Report to the Future Melbourne (Planning) Committee

**Ministerial Planning Referral: TPM-2019-19
150-170 Pelham Street, Carlton****15 September 2020****Presenter:** Evan Counsel, Director Planning and Building**Purpose and background**

Level 7 outdoor terrace test locations

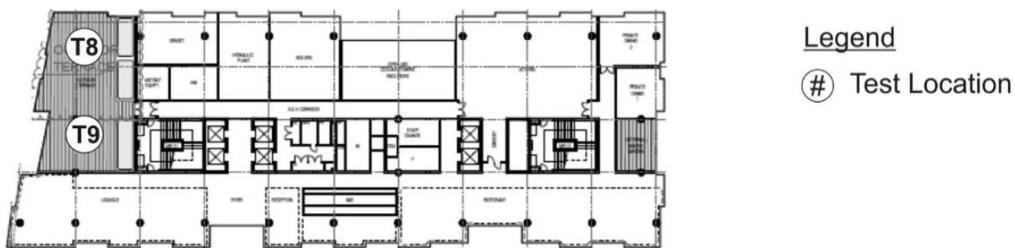
- The wind conditions on all outdoor terraces should be assessed and a BMS should be provided for all terraces that do not meet sitting criterion.
- The June 2019 wind report indicates that 2.4m high balustrades are required for the outdoor terrace on level 7 to meet walking criterion in location T7 and standing criterion in locations T1 and T10. The 2.4m high balustrades should be shown on the architectural plans, if they are required. This change would increase the height of the 'podium' element.
- The wind conditions at the building and through block link entrances meet or exceed standing criterion.
- The wind conditions at the pedestrian transit areas meet or exceed walking criterion.
- The development will not change the wind comfort at the test locations in Lincoln Square and University Square.

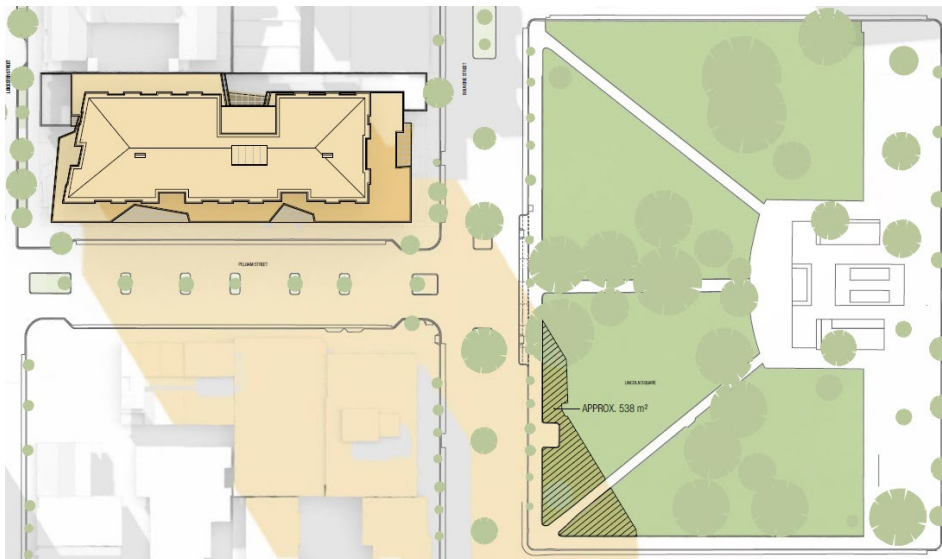
- The overshadowing to Lincoln Square at 2pm and 3pm on 21 June significantly increases when Lincoln Square is plotted in its as-built, expanded form.

- The development exceeds the proposed mandatory overshadowing controls by approximately 1,153m² at 2pm and 3,114m² at 3pm on 21 June.
- The proposed variations to the built form controls in DDO61 increase overshadowing to Lincoln Square by approximately 715m² at 2pm and 1,295m² at 3pm on 21 June.

It is considered that the shadow cast by the development would unreasonably affect the amenity of Lincoln Square at 2pm and 3pm on 21 June.
